**AMENDMENT 5**

**Invitation for Bid (IFB)  
UOG IFB No. B23-01**

UOG INVITATION FOR BIDS NO. B23-01:  
MULTI-STEP SEAL BID FOR CONSTRUCTION SERVICES

**QUESTION & ANSWER SHEET NO. 3**  
**July 25, 2023**

2 **2' X4' HANDHOLE DETAIL**  
E501 NTS

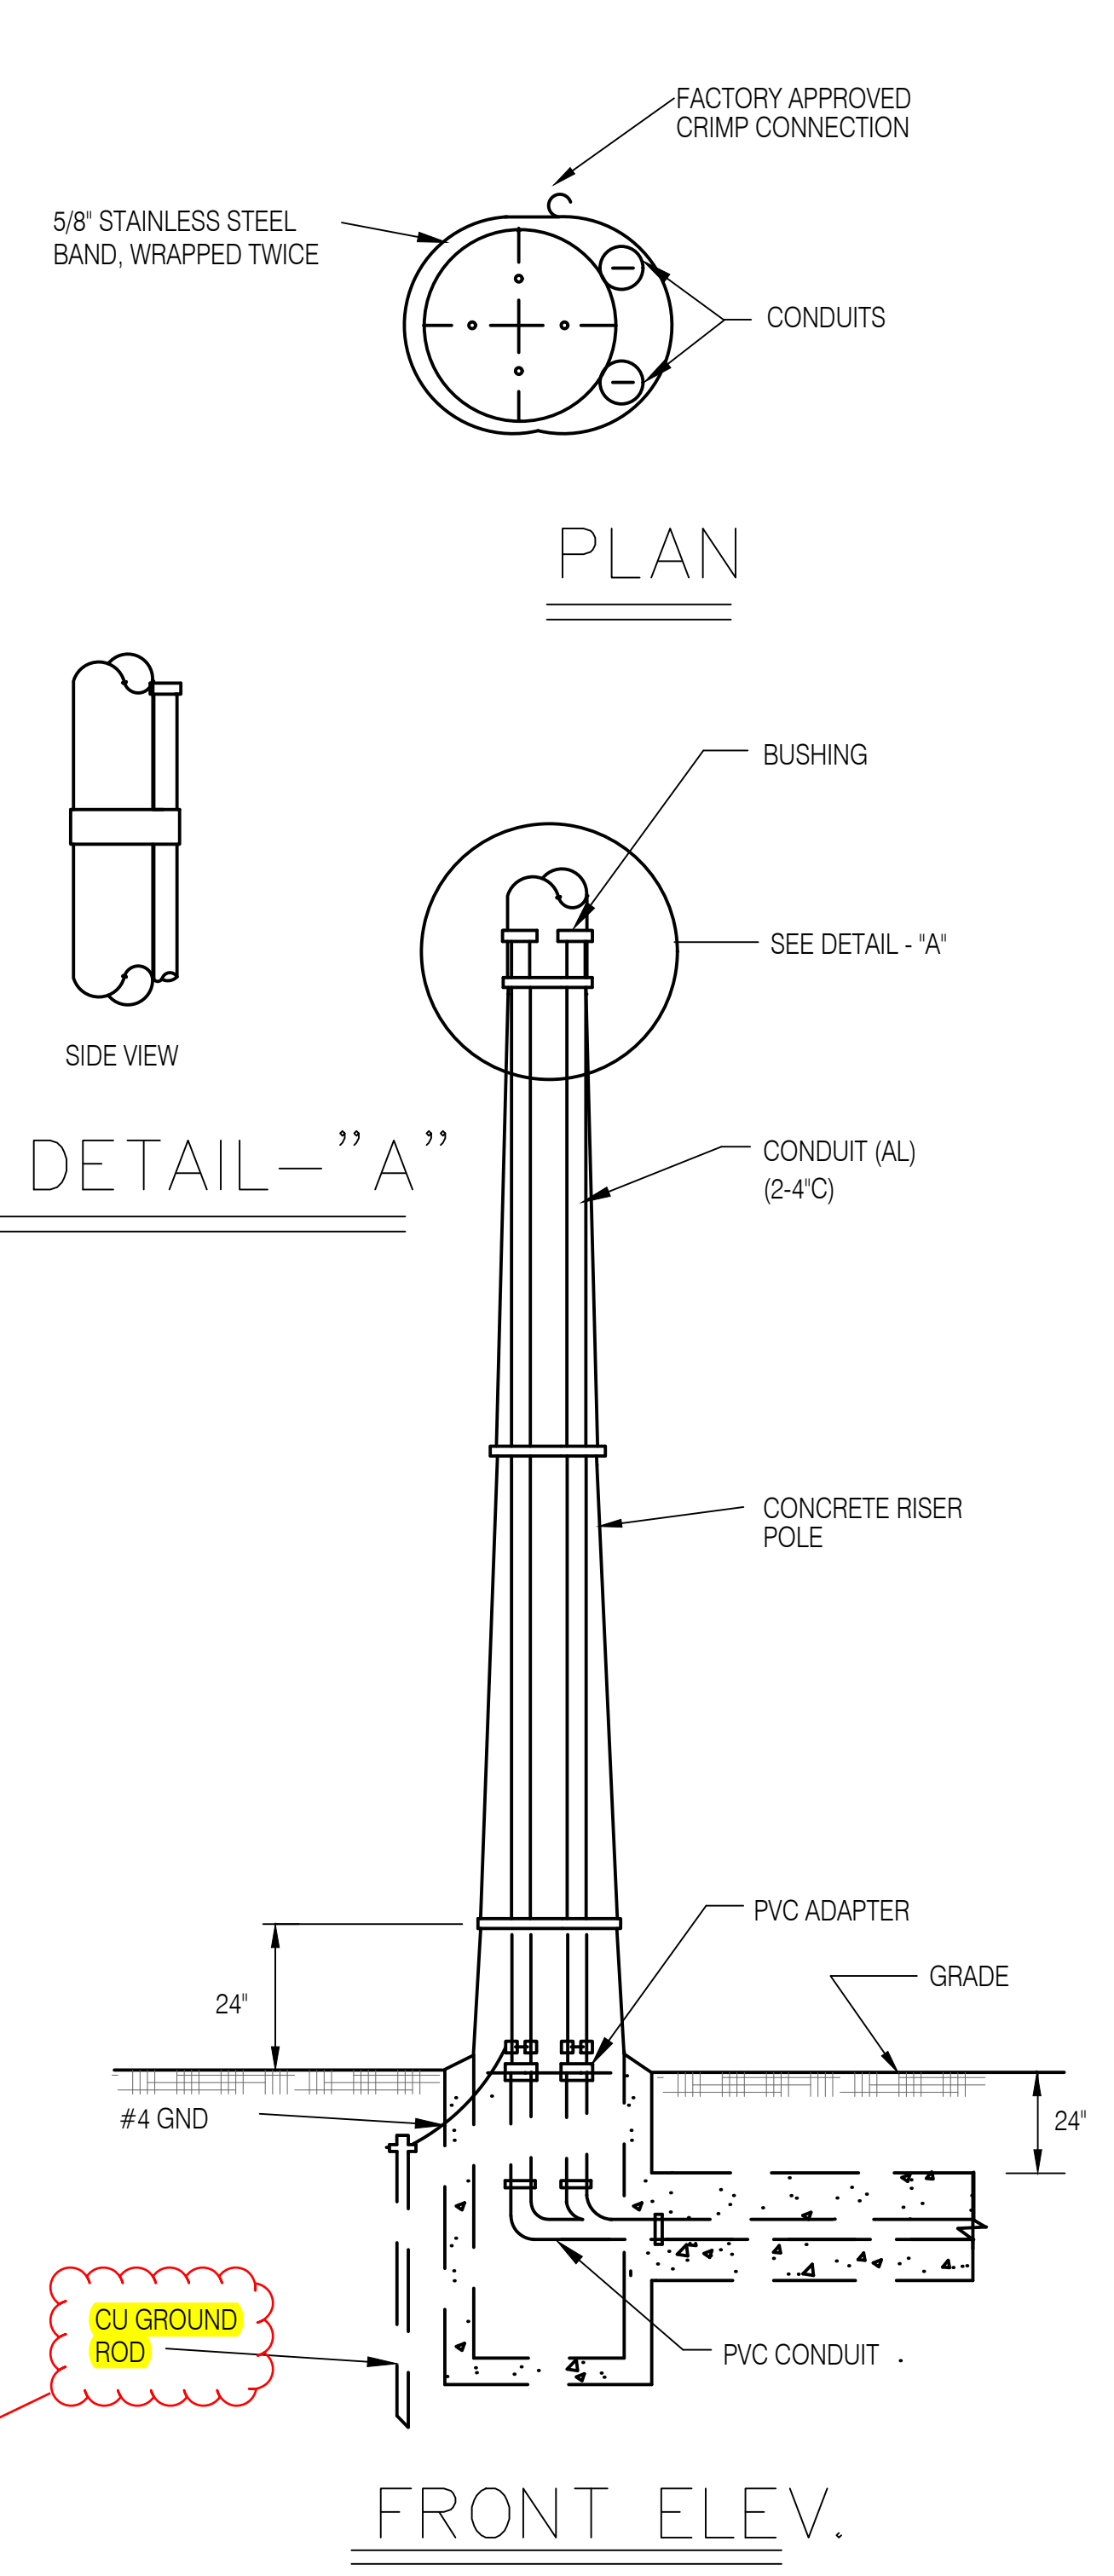
Please confirm ground rod size to be used

Please confirm if this is a man hole or a hand hole as compared to 2ES101.

Handhole

3 **PAD MOUNTED TRANSFORMER DETAIL**  
E501 NTS

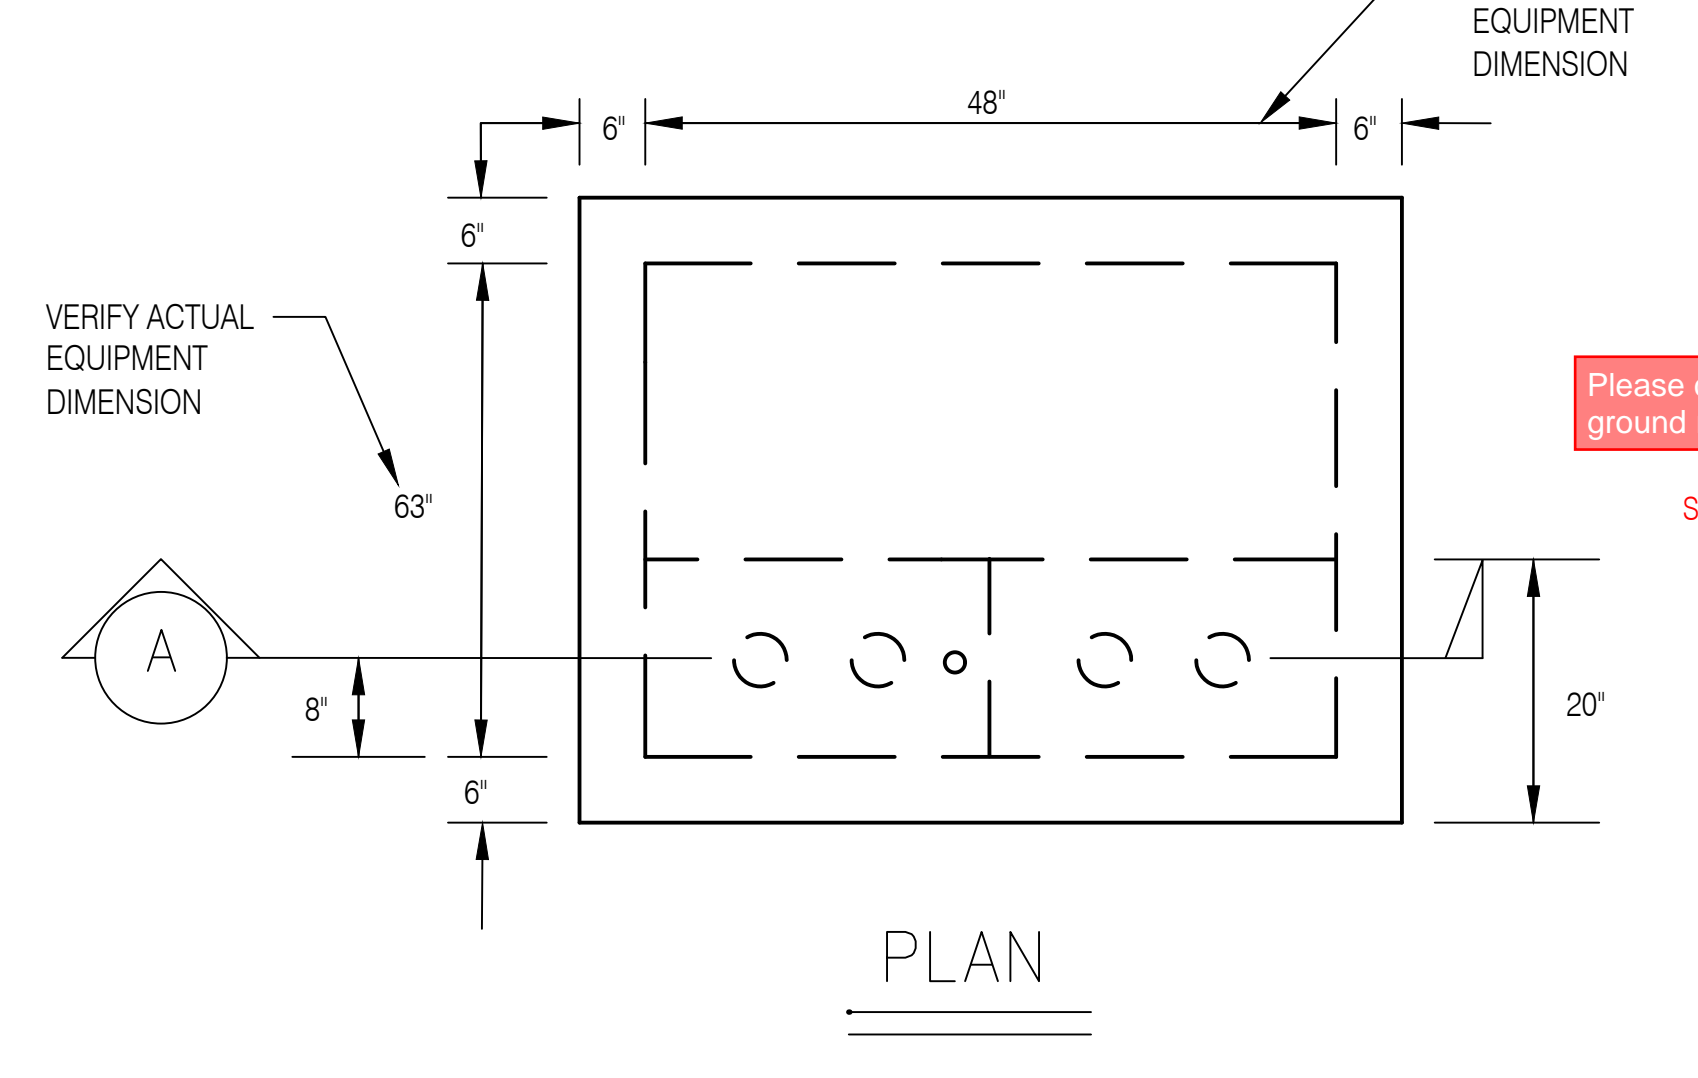
VERIFY ACTUAL EQUIPMENT DIMENSION
